MODEL }  
MODÈLE } **61**

### NEW CARBURETTOR

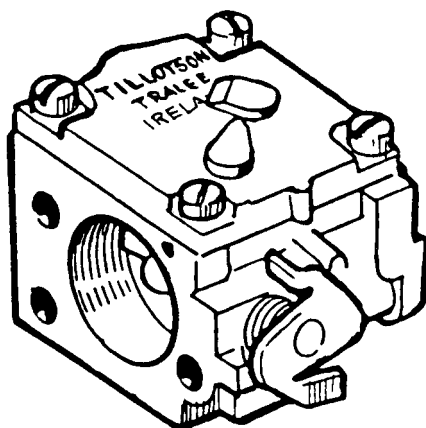
Carburettor Walbro WS 17 A, part No. 501 69 27-01 is excluded and replaced by Tillotson HS 163A, part No. 501 52 77-01 (reintroduced).

Basic adjustment for Tillotson HS 163 A is:

L = 1.0 turn open

H = 0,75 turn open
